Submission on Contact Energy Limited's Lake Hāwea Draft Erosion Management Plan

28 July 2021

Guardians of Lake Hāwea

Fig 2. Screen shot taken from Hāwea Community Centre Website of the Wedding Tree site on Flora Dora Cliffs, cliff edge information added.

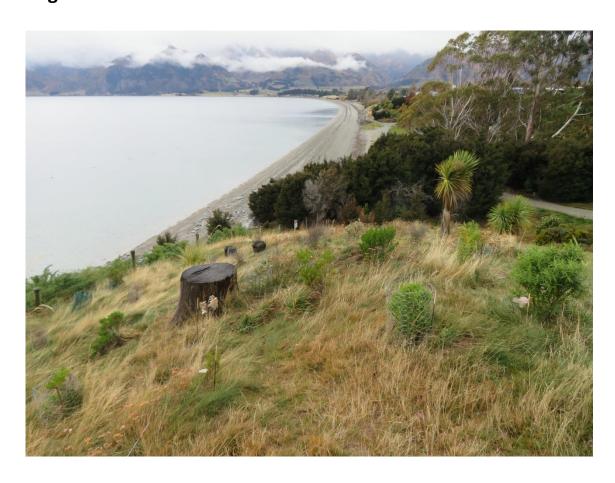
In addition, the eastern area of the Flora Dora reserve has a large Gum tree which is a very popular area for social gatherings. Evidence of the popularity of this area is evident by Lake Hāwea Community Centre advertising (see: https://lakeHāwea communitycentre.co.nz) (see Fig 2). This area has also been the subject of extensive revegetation (Fig 3) by a group of volunteers (Thursday Group) working in partnership with QLDC. In summary, the Hawea community considers this area to be an important community asset and, as such, it warrants protection to ensure that further erosion is avoided.

Given the significant amenity value associated with Flora Dora terrace and recent cliff collapses it is now appropriate to review the mitigation options. While we do not have specific expertise in terms of options for mitigation, we note that a mix of strategies may be required. We offer the following comments on some of the options presented by Silvester (2014).
